Private Fuel Storage, L.L.C.

June 2, 2000

COMMITMENT RESOLUTION LETTER #34
DOCKET NO. 72-22 / TAC NO. L22462
PRIVATE FUEL STORAGE FACILITY
PRIVATE FUEL STORAGE L.L.C.

A meeting was held on May 25, 2000 in San Antonio, Texas between Private Fuel Storage (PFS), Stone and Webster (S&W), and the NRC/CNWRA to discuss several open issues remaining with the Private Fuel Storage Facility (PFSF) Safety Analysis Report (SAR). The topics discussed and the PFS actions necessary to resolve these issues are outlined below.

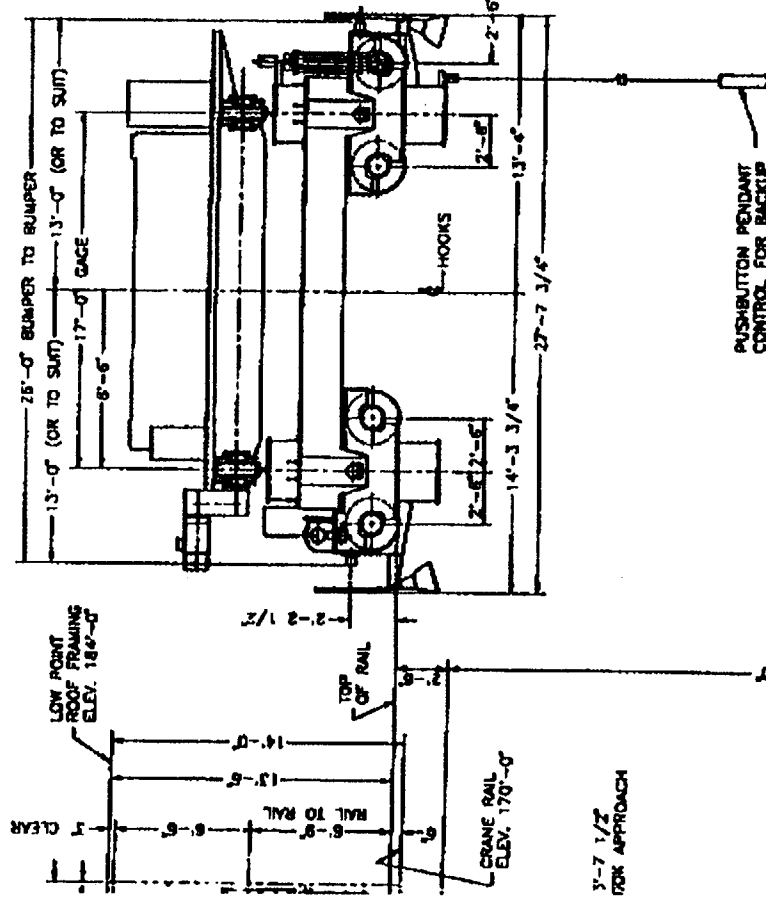
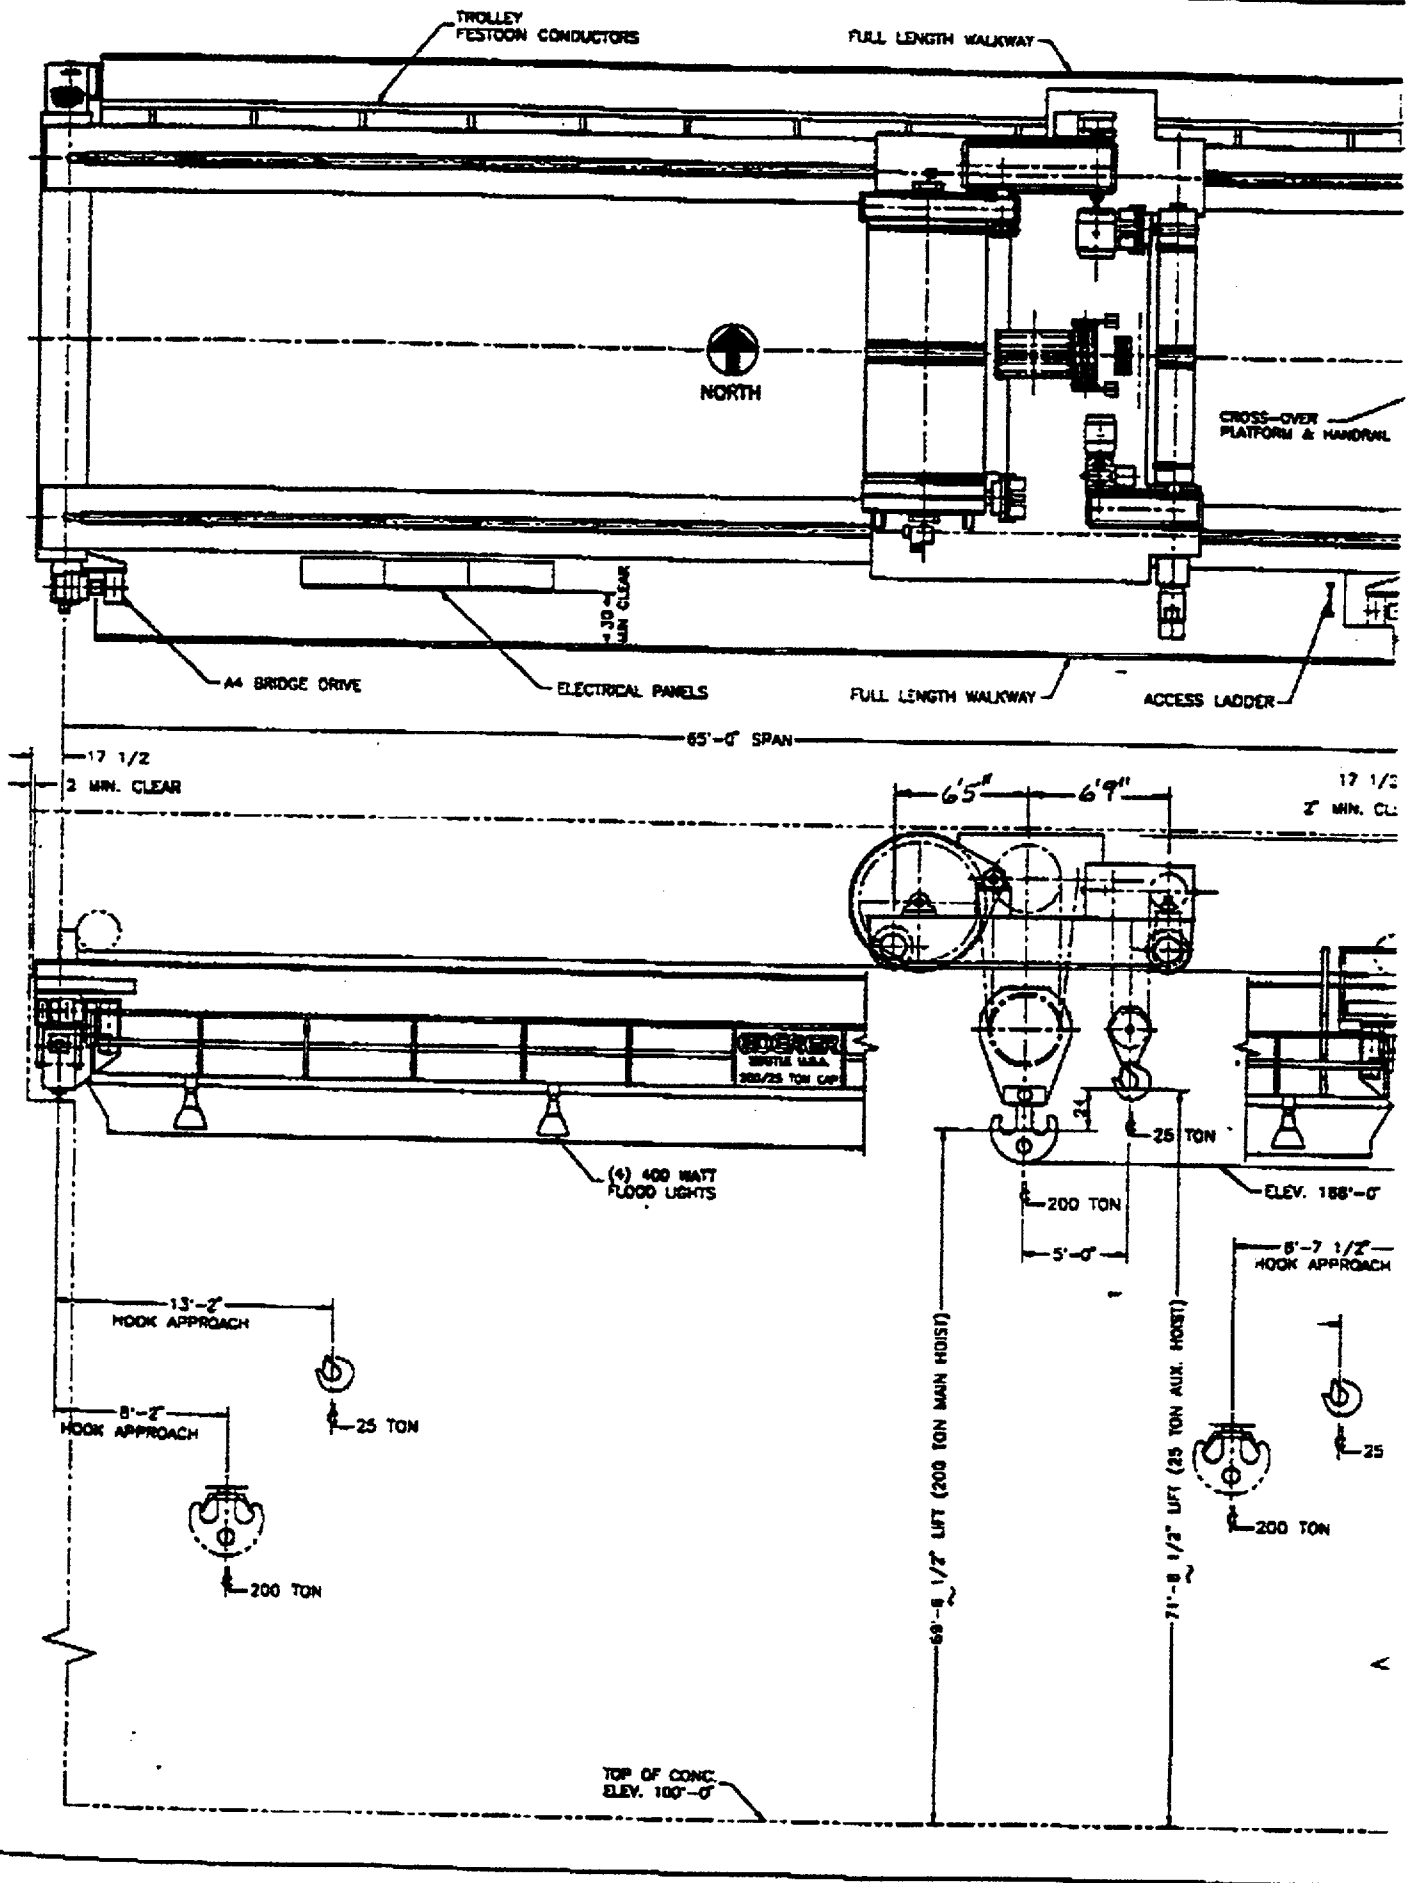
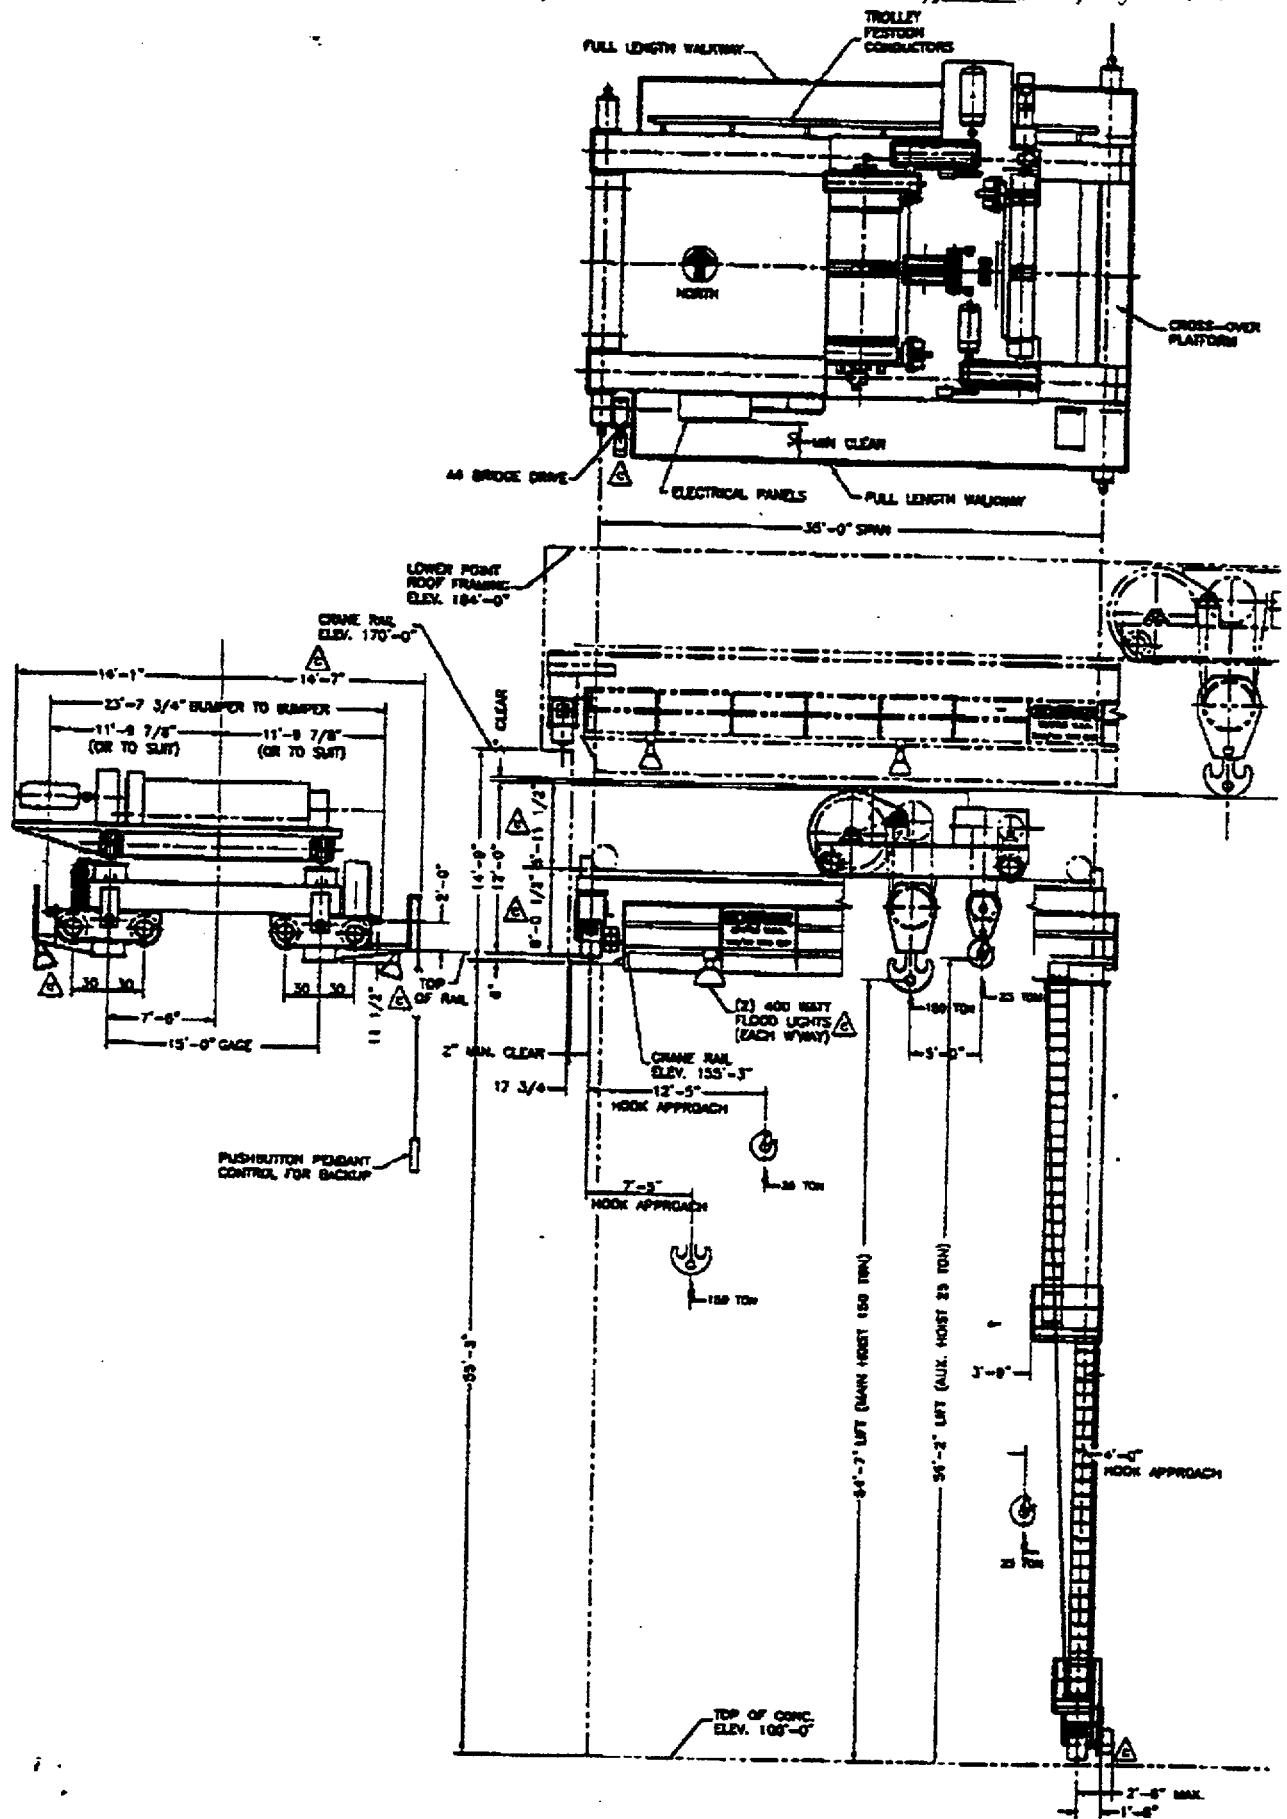
For the 200T bridge crane, the vertical peak change is +14%. The N-S lateral forces are governed by wheel slip and will remain constant. Since the bridge girders, trolley trucks, trolley girder and equalizing sill are at approximately 90% or more of the allowable stress and this margin should be maintained, the section moduli would have to increase approximately 14%. The bridge trucks will be also affected by the large E-W horizontal peak change (+100%). They are however at a lower % allowable stress of $\approx 72\%$. The section modulus for the trucks would then have to increase approximately 10%. See Appendix A for a sample calculation. Our conclusion is that the bridge crane will still fit in the same envelope as shown on PA-2189, Rev. B but will be somewhat heavier.
